Agenda
Hearing Examiner Meeting
Thursday, May 4, 2017
City Hall Council Chamber | 505 Swift Boulevard

S2017-101 - An application submitted by Mark Bauder for the Preliminary Plat of Westcliffe Heights to divide 140 acres into 203 single family residential lots. The project site is located on Little Badger Mountain.

**CITY OF RICHLAND DEVELOPMENT SERVICES DIVISION
STAFF REPORT TO THE HEARING EXAMINER**

PROPOSAL NAME: Westcliffe Heights - Preliminary Plat

Exhibit 1

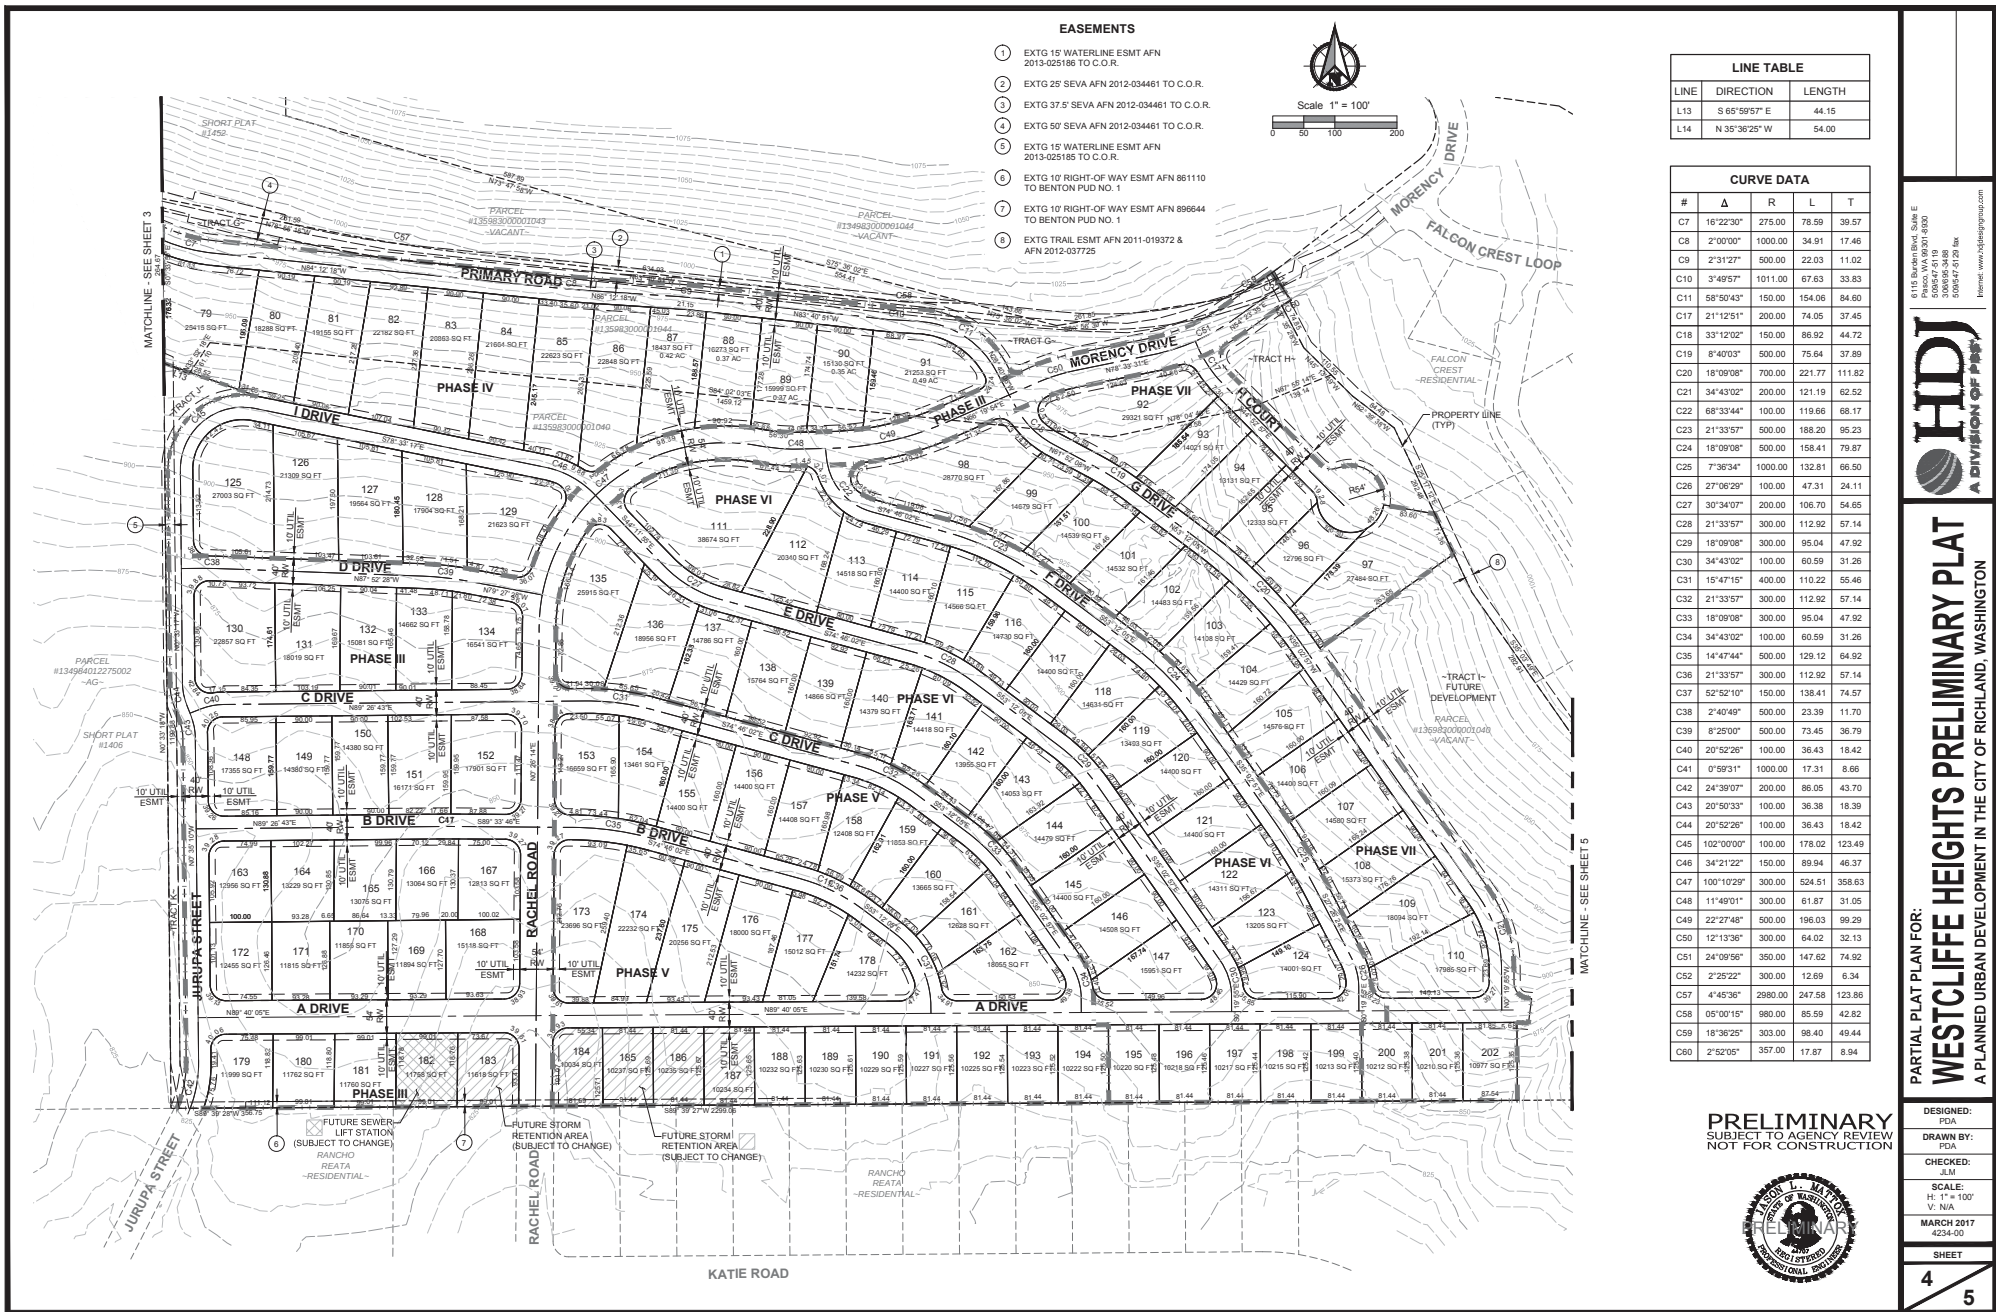
1. Tract "D" should be labeled as a "Storm Drainage Tract" and not as "Future Development", per discussions with the developer and his engineer.
2. The BMID pond needs to be shown on sheet 1.
